MEETING NOTES

PROJECT:	23982-23929 I-70 West Vail Pass Safety and Operations Improvements
PURPOSE:	ALIVE ITF #3 Meeting
DATE HELD:	February 10, 2021
LOCATION:	Online Google Meet Meeting
ATTENDING:	John Kronholm, Project Manager, CDOT Region 3 Karen Berdoulay, Resident Engineer, CDOT Region 3 Rob Beck, Program Engineer, CDOT Region 3 David Cesark, CDOT Region 3 Matt Figgs, CDOT Region 3 Cinnamon Levi-Flynn, CDOT Jeff Peterson, CDOT Carole Huey, US Forest Service Jen Prusse, US Forest Service Kristin Salamek, CDOT USFWS Liaison Michelle Cowardin, DNR Jeff Bellen, FHWA Stephanie Gibson, FHWA Pete Wadden, Town of Vail Jen Bradtmueller, Kiewit Jim Thomsen, Kiewit Julia Kintsch, ECO-resolutions Paige Singer, Rocky Mountain Wild Jillian Mauer, Pinyon Environmental Randal Lapsley, R S & H Mary Jo Vobejda, Jacobs Jim Clarke, Jacobs Jacobs Loretta LaRiviere, Jacobs Loretta LaRiviere, Jacobs
COPIES:	Attendees

*Approximate location for structure.

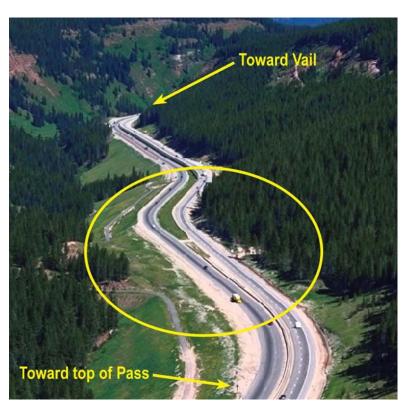
After discussion, the consensus from the panel is mile marker 187.4 is the selected location for the overpass structure because of the engineering characteristics of the site and the wildlife use of the site appears to be high in that area.
